Four Winds –

Copy of previous reports etc. relevant to correspondence sent to
DCC Members post March 2011 Committee

SURVEY AND STRUCTURAL REPORT

COMMENTS ON SEVENOAKS COUNCIL'S ENGINEERS OPINION

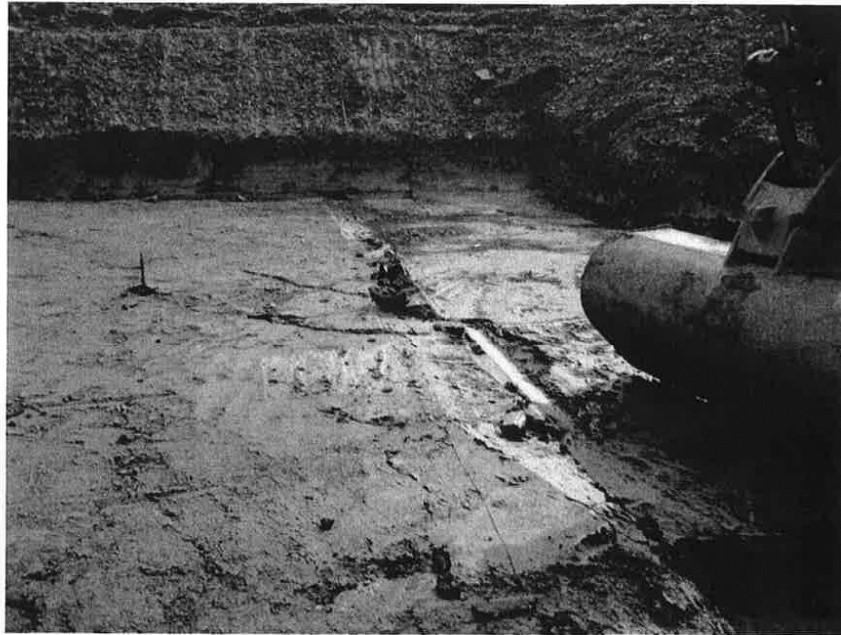
Sheet piles being put in place and hammered down.

The line of sheet piles against our neighbours eastern boundary which subsequently had to be re “planted”

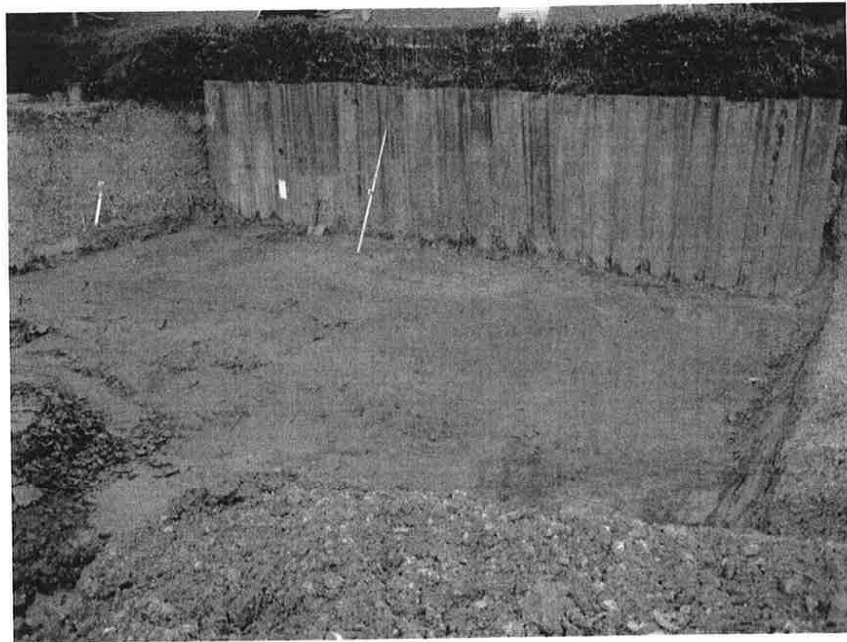
This picture shows the Black gault clay at the slightly lower level as opposed to the red / flinty clay on the sides. You can see that we went down to the points where we encountered the black clay.

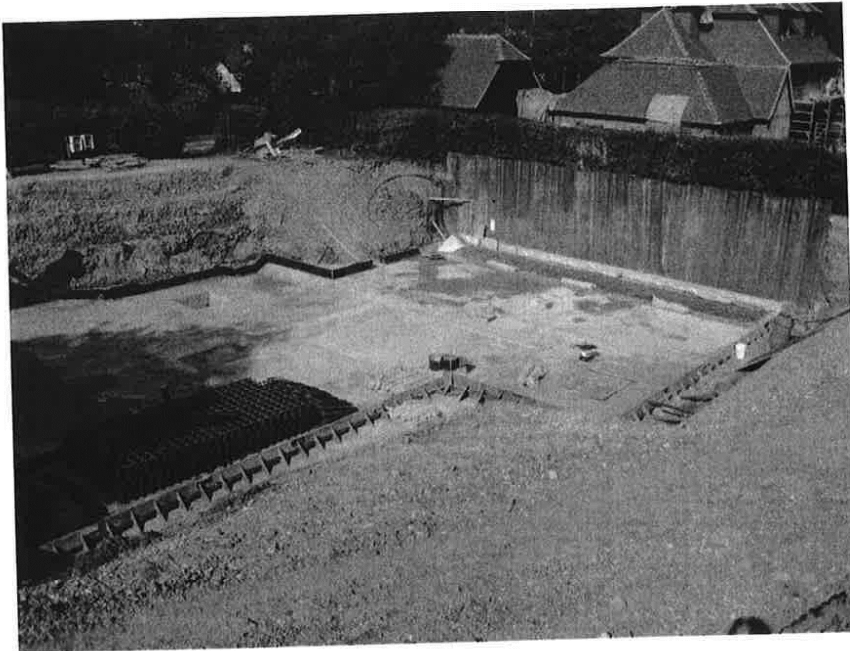
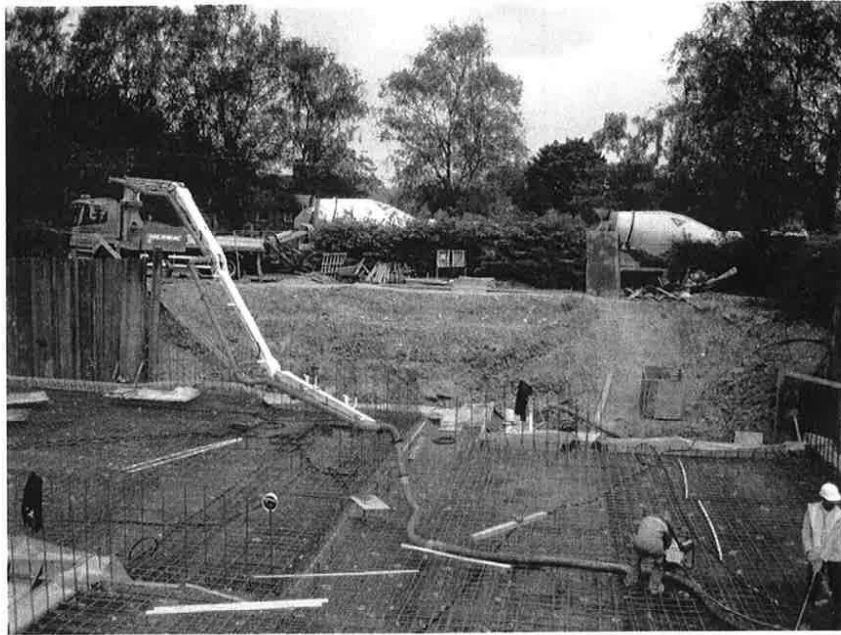
This picture shows you the eastern boundary and its piling. You can also see the water in the right corner, and this is after little or no rain for more than a month.

Opps there go the piles just a few hours after the Digger had been taking away necessitating its return at vast expense to put them in again and sort out the collapsed ground.

This picture is of the ground to the Western boundary, but the same thing happened to the eastern boundary piling, though for some reason I don't have a picture for this.

The screed slab area. You can also see just behind the sheet piling how great chunks of ground would just “sheer” off. You can also see this happening at the other end of the sheet piling where there is the beginning of a mound of earth appearing. This happened a lot.

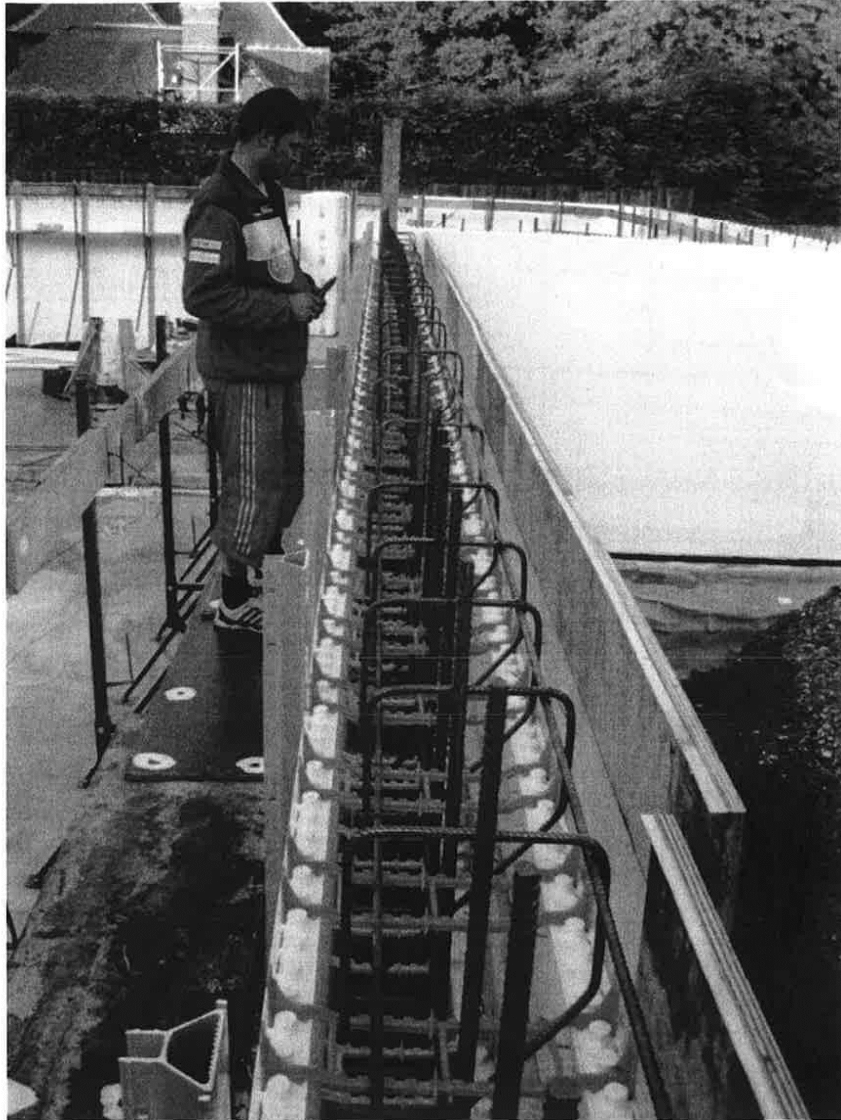
The slab area in preparation for the bentonite material that forms the waterproofing membrane. You can see the first couple of sections.

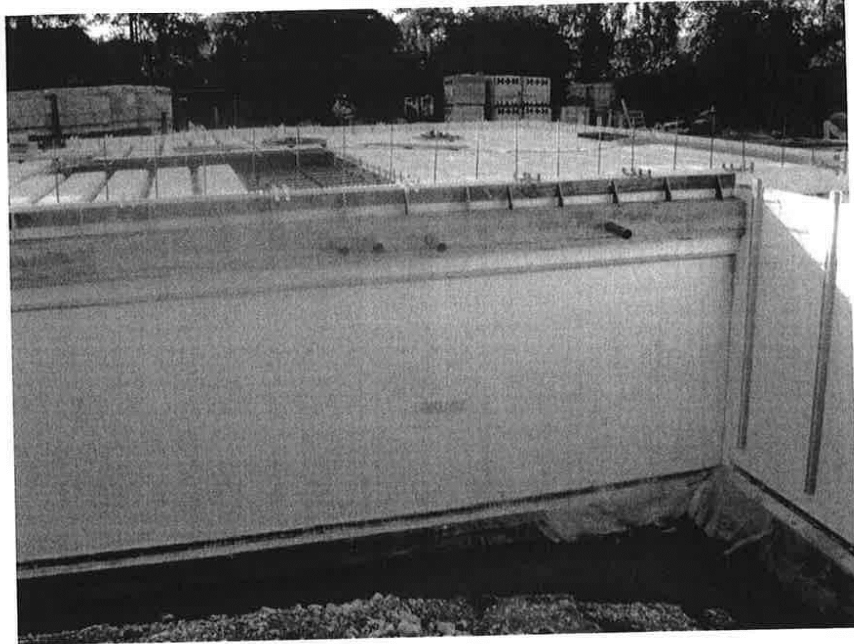
Just at the beginning of pouring the slab..... that's the SINGLE slab..... atleast that's how it looks to me!

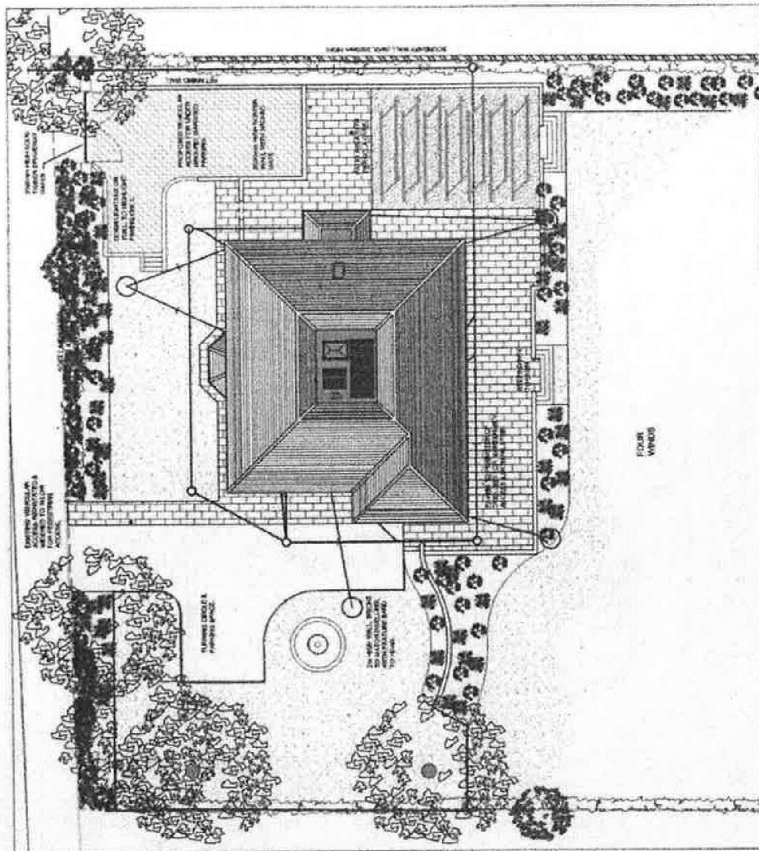
There is some steel in those walls to reassure you.... You can also see the water in the outside corner of the building around the bottom of the slab. By then we had a pump hooked up to pump it out continuously.

Water.
